QSFP-DD SMT MCB/HCB Performance vs. 802.3ck D1.2

Alex Haser (alex.haser@molex.com)
10 June 2020

- OBJECTIVE: To evaluate DDQ SMT (1x1) performance against the 802.3ck D1.2 MCB/HCB limits
 - Several parameters have not yet been defined
 - The data presented will be used to determine a proposal for these undefined parameters
- Both simulated and measured data sets are presented
 - Simulated data captures the performance of the entire connector
 - Measured data is more realistic, but only “proof of concept” (POC, partially populated) results are available, so the data set is incomplete

SDD21:

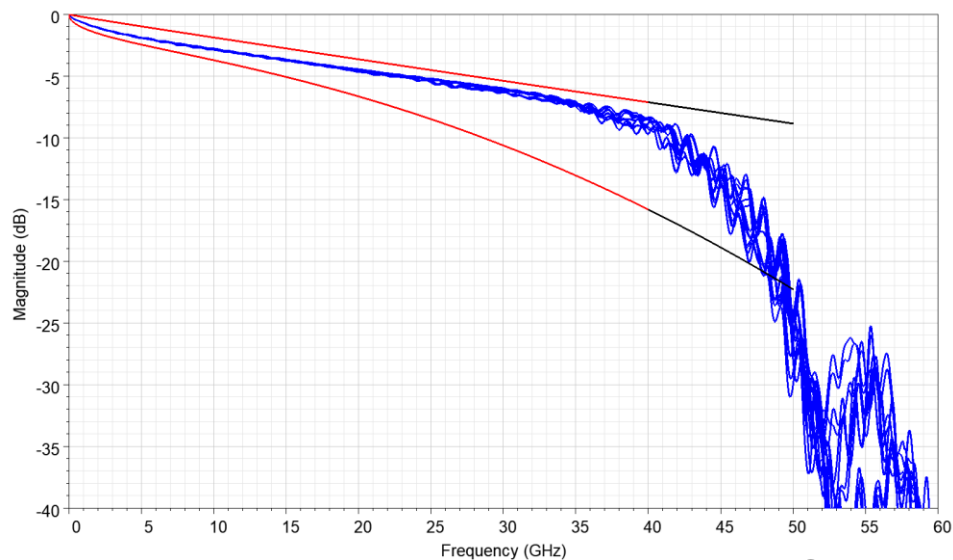
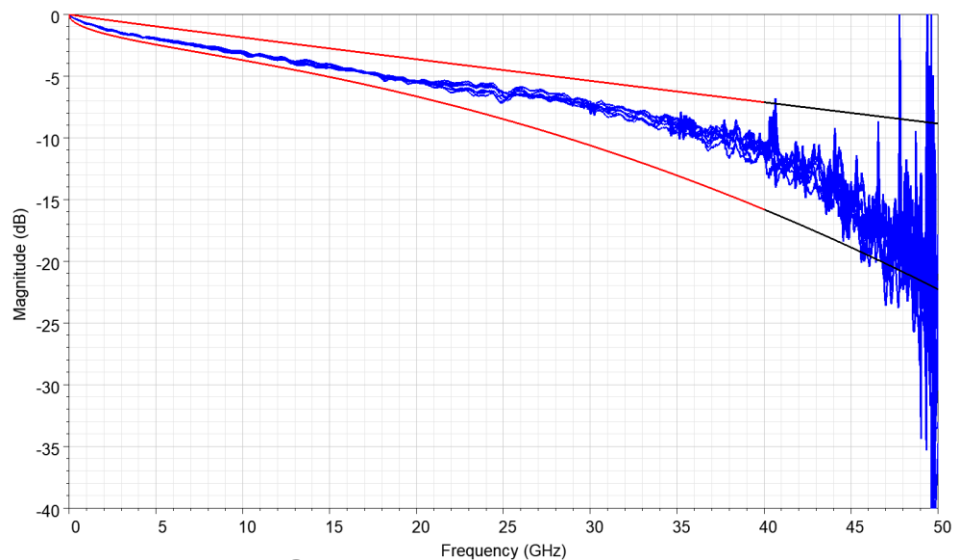
Proposal: Stop limit lines at 40 GHz

SDD11:

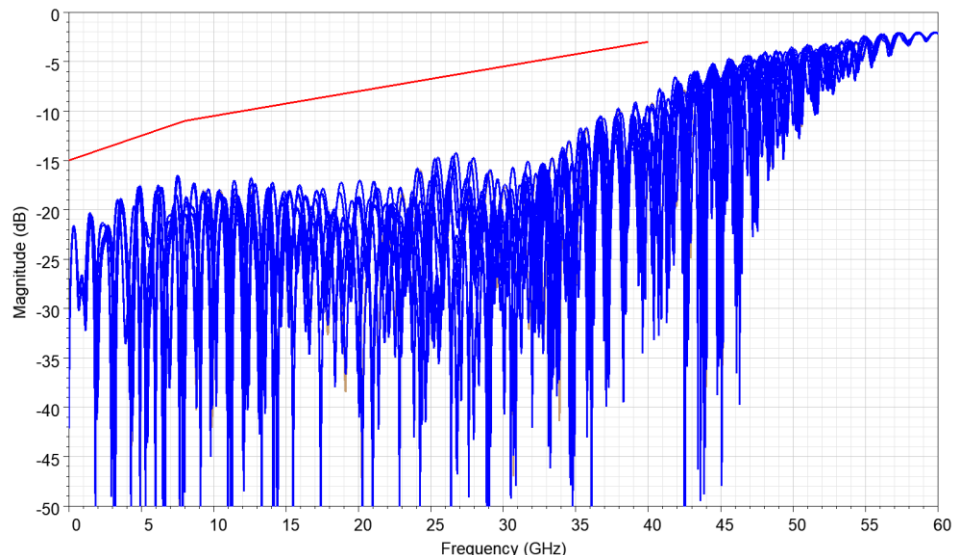
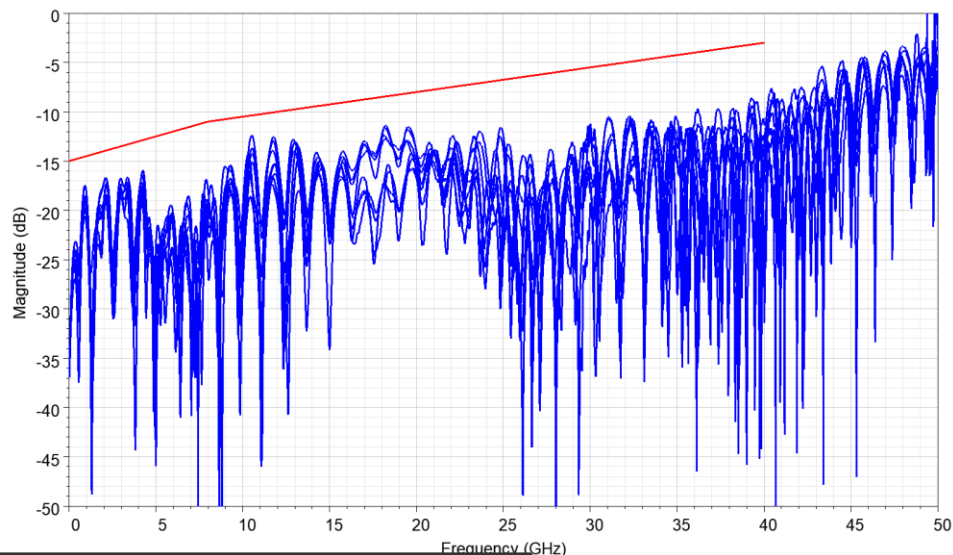
NOTE: 802.3ck D1.2
does not include a limit
line for this parameter

Proposal: $15 - 0.5f$
 $13 - 0.25f$

$f < 8 \text{ GHz}$
 $8 \text{ GHz} \leq f \leq 40 \text{ GHz}$

SDD22:

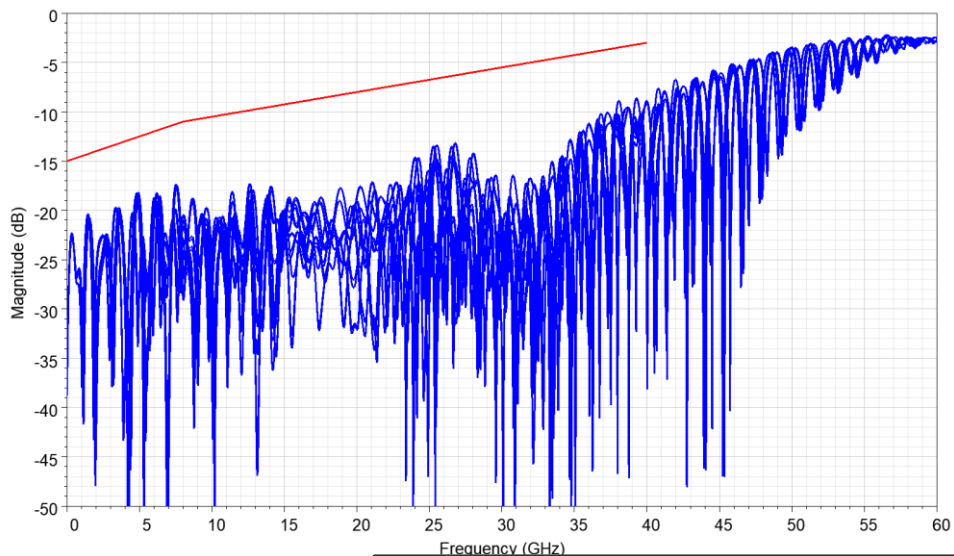
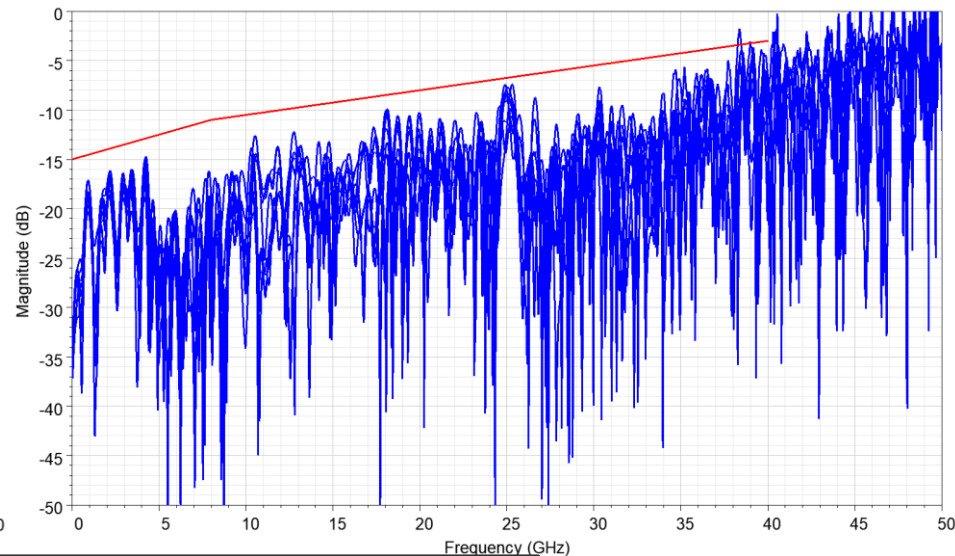
NOTE: 802.3ck D1.2
does not include a limit
line for this parameter

Proposal: $15 - 0.5f$ $f < 8 \text{ GHz}$
 $13 - 0.25f$ $8 \text{ GHz} \leq f \leq 40 \text{ GHz}$

SDC12:

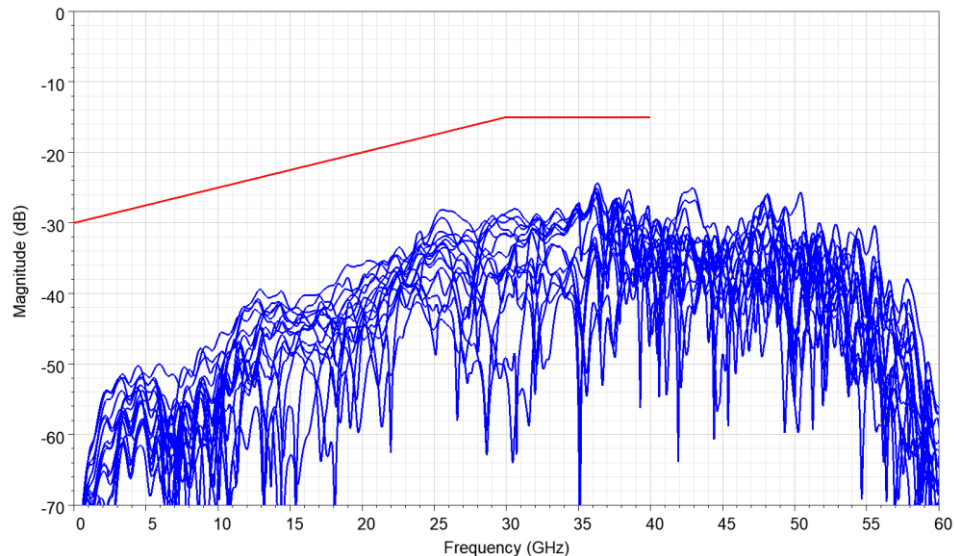
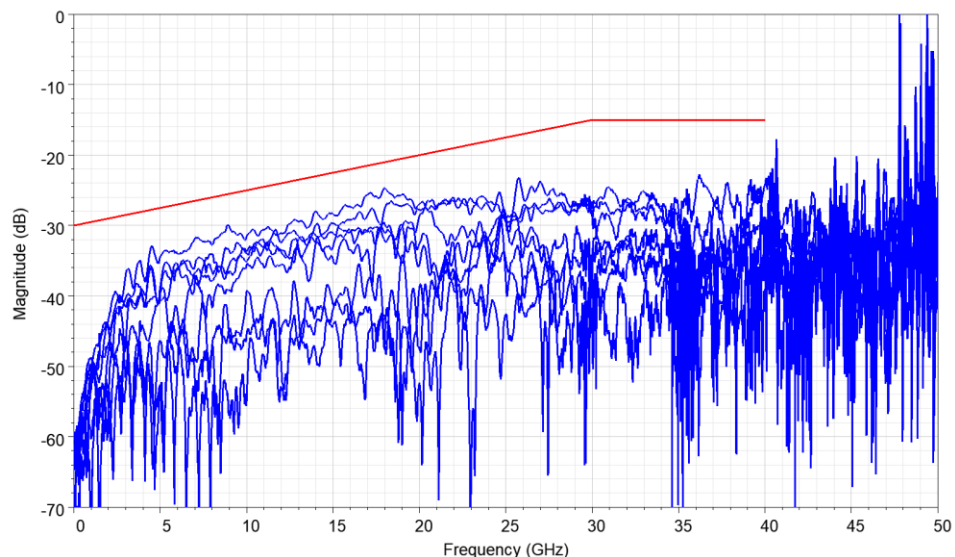
NOTE: 802.3ck D1.2
does not include a limit
line for this parameter

Proposal: $30 - 0.5f$
15

$f < 30 \text{ GHz}$
 $30 \text{ GHz} \leq f \leq 40 \text{ GHz}$

SDC21:

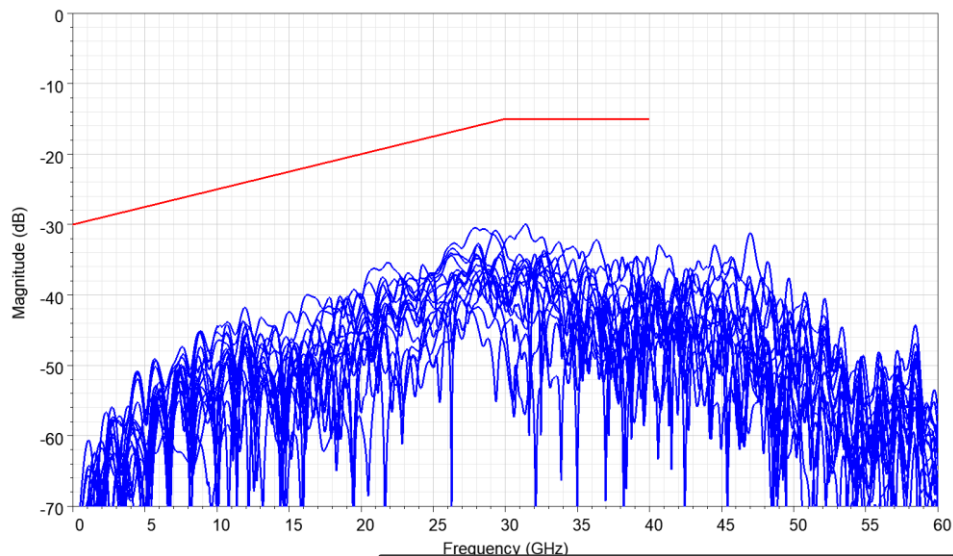
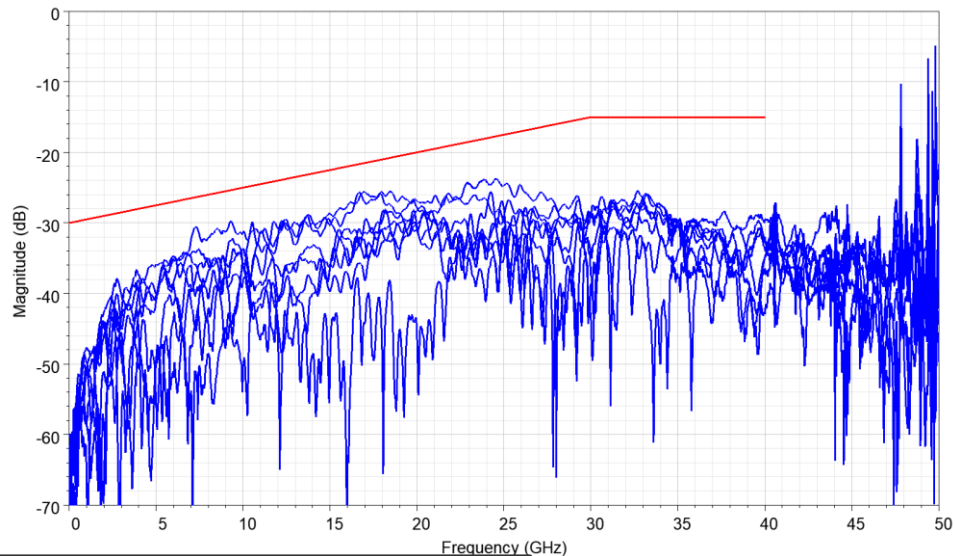
NOTE: 802.3ck D1.2
does not include a limit
line for this parameter

Proposal: $30 - 0.5f$
15

$f < 30 \text{ GHz}$
 $30 \text{ GHz} \leq f \leq 40 \text{ GHz}$

SDC11:

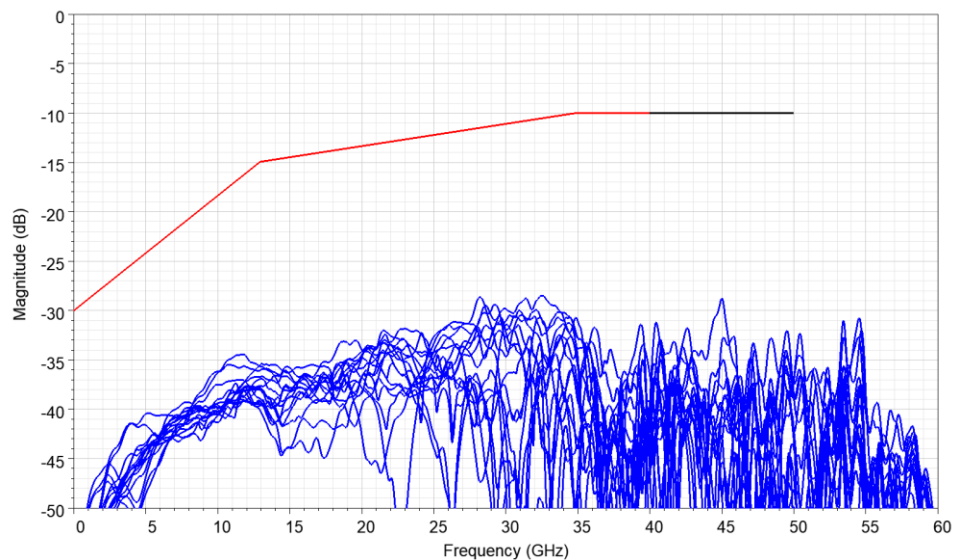
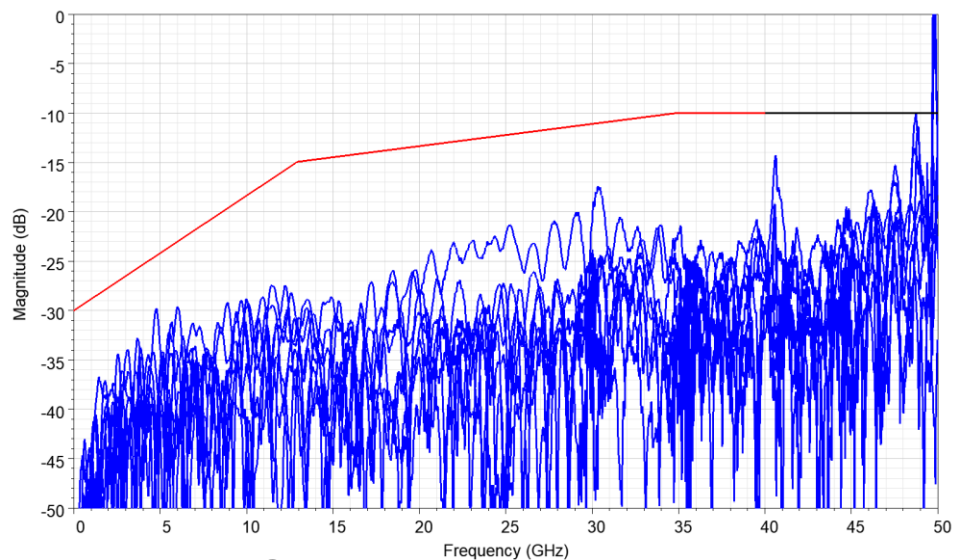
Proposal: Stop limit line at 40 GHz

SDC22:

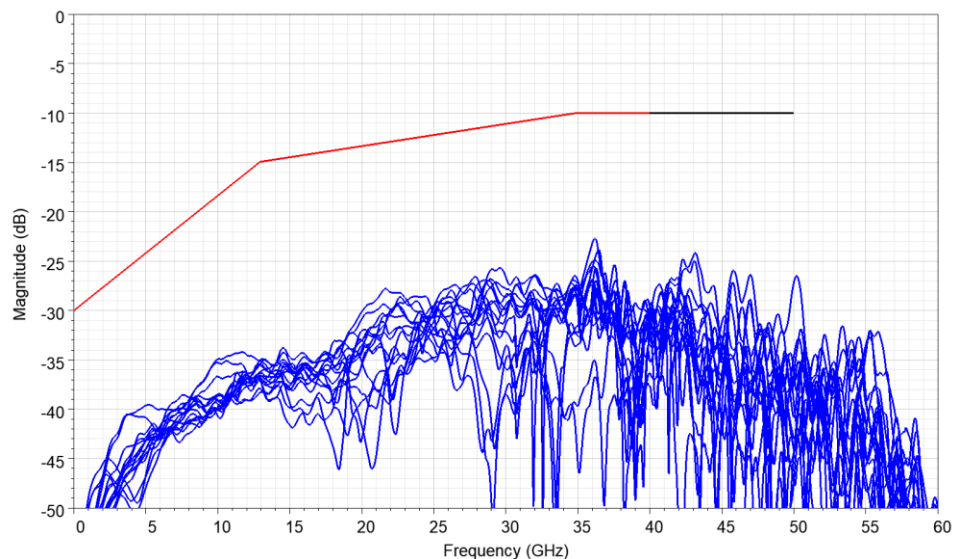
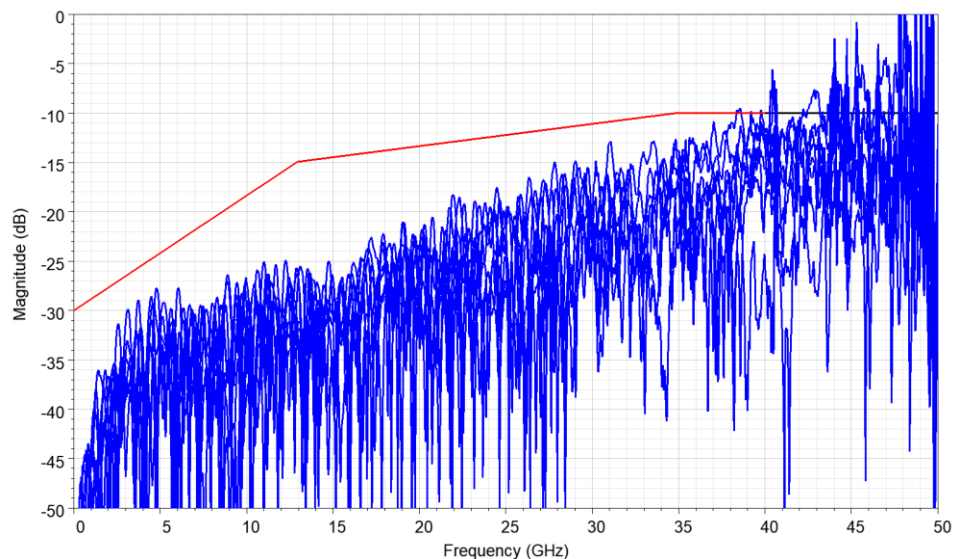
Proposal: Stop limit line at 40 GHz

SCC11:

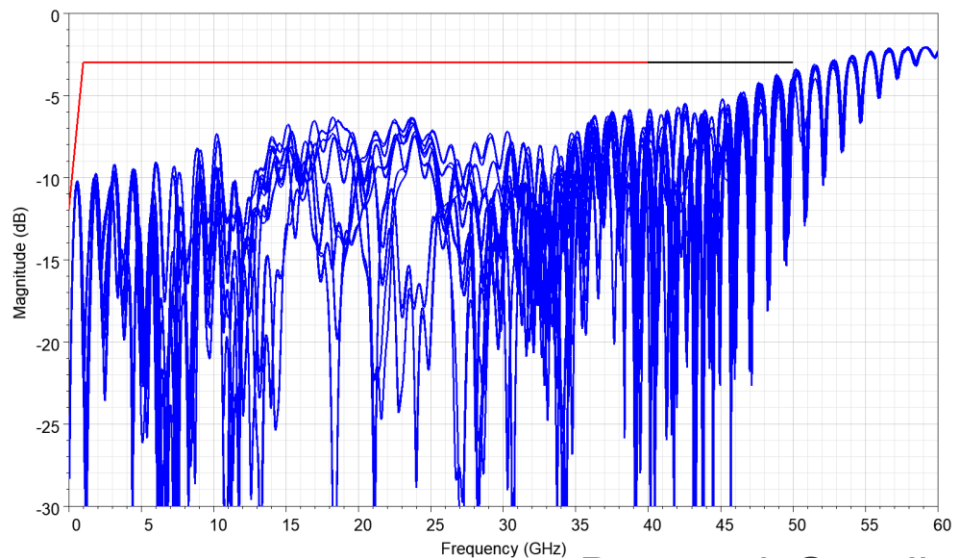
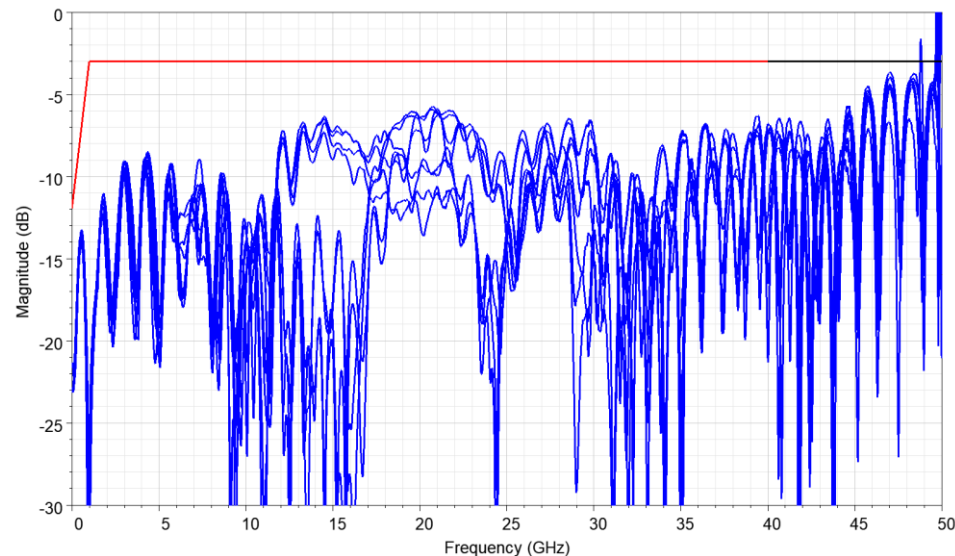
Proposal: Stop limit line at 40 GHz

SCC22:

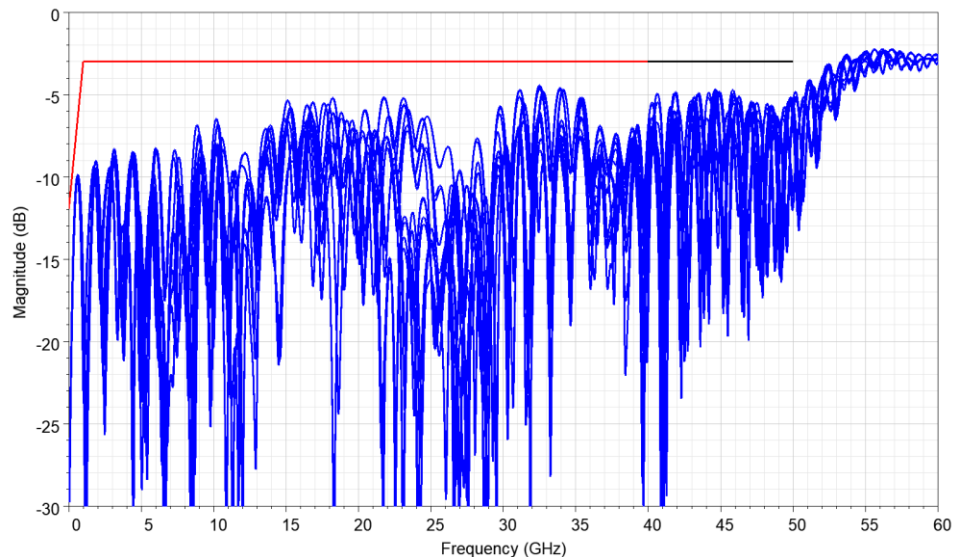
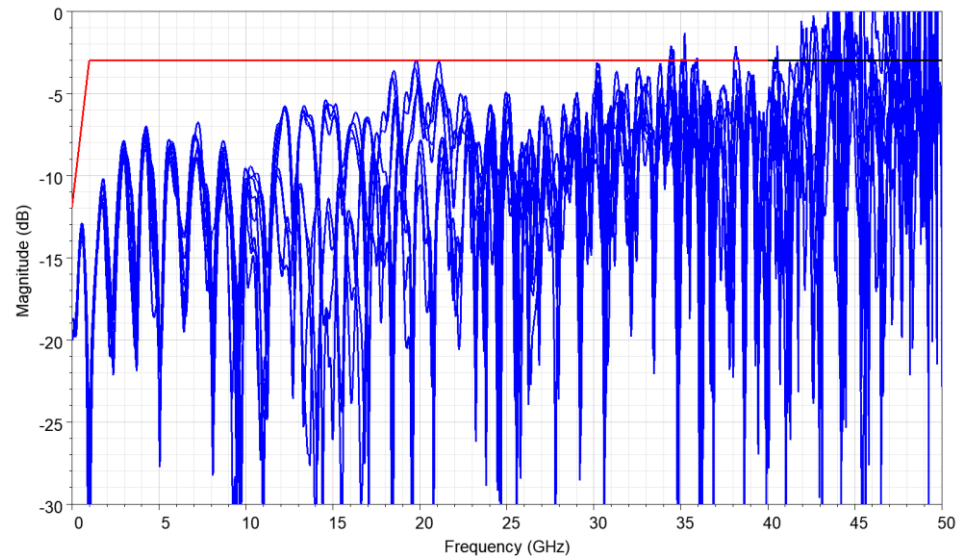
Proposal: Stop limit line at 40 GHz
